UNITED STATES PATENT AND TRADEMARK OFFICE

APPLICATION NO.	FILING DATE	FIRST NAMED INVENTOR	ATTORNEY DOCKET NO.	CONFIRMATION NO.
10/511,071	10/12/2004	Steven Victor Jones	BR8812	7044

Office Action Summary	Application No. 10/511,071	Applicant(s) JONES	
	Examiner Katherine W. Mitchell	Art Unit 3677

DETAILED ACTION

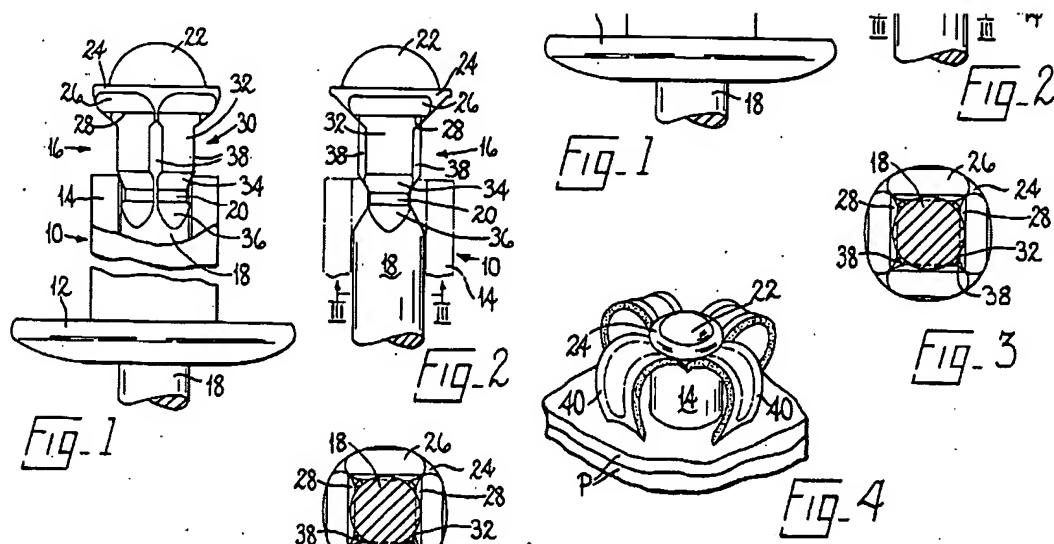
8. Claims 1-2 are rejected under 35 U.S.C. 102(b) as being anticipated by Potzas USP 4620825.

Re claims 1-2: Potzas in Figs 1-4 (above) teaches Potzas teaches a peel type blind rivet (abstract) settable in soft material, having an elongate body 10 with a shank and preformed head 12 at one end, and a plurality of slots 12 terminating at the end remote from the head. There is a mandrel (16, column 2 lines 49-50) having a stem (18) which extends through coaxial with said body and having an enlarged head (22) with a maximum external diameter greater than the internal body diameter (Figs above). The mandrel head forms a shoulder between the mandrel stem and an outer surface of the head, -- the deforming means (head) presents a substantially flat surface perpendicular to an axis of said mandrel, in that the underside of head 22 terminates in plane forming flat shoulders 28 normal to axis of stem, which as shown in Figs 1- 4 and discussed in column 2 lines 62-68 is described as "flat shoulders 28 normal to the axis of the mandrel".
